# SERVICE No. 1026 BULLETIN

DATE: November 5, 1998 (S/M)

Distribution of Parker Hannifin Airborne  
Service Letter 48, "Inspection/Replacement  
of dry air pump flexible couplings".

**Subject:** Inspection/Replacement of dry air pump flexible couplings.

**FIGURE 1**

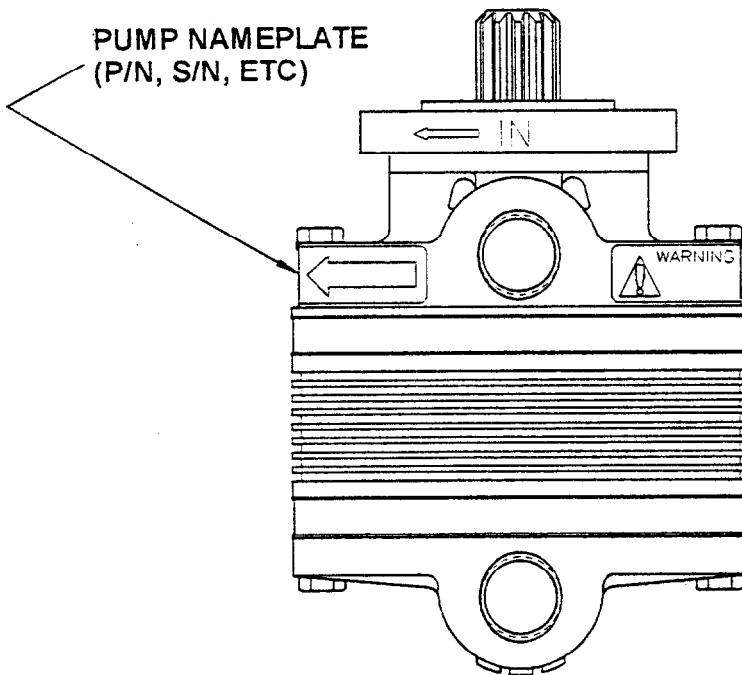
**Applicability:** Airborne dry air pumps, conversion kits and flexible coupling kits with the following part numbers/serial numbers which have not been inspected per this service letter as identified in step number seven of the procedure listed below. These components were shipped from Airborne between 1/1/98 and 10/13/98. Refer to Figure 1 for location of part number/serial number nameplate.

FIGURE 2

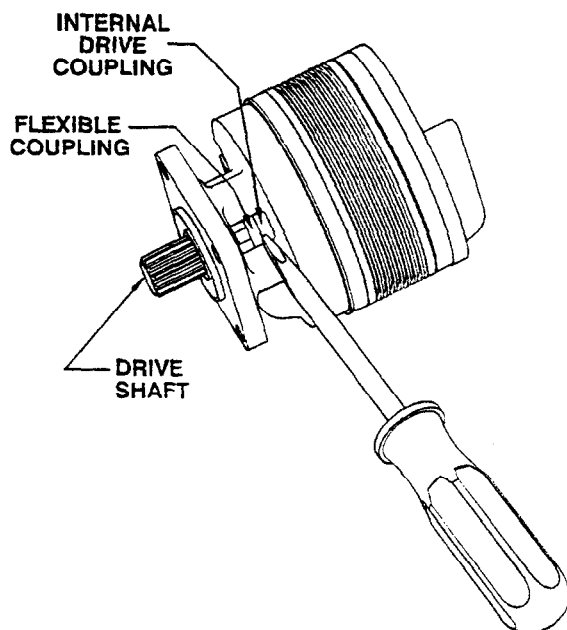
- 1) Remove dry air pump from engine accessory pad per instructions provided by the airframe manufacturer in the appropriate maintenance publication.
- 2) Insert a screwdriver or similar tool between the flexible coupling assembly (2-piece) and the pump's internal drive coupling. Remove the flexible coupling assembly from pump, taking care not to damage any of the eight drive pins. Refer to Figure 2.
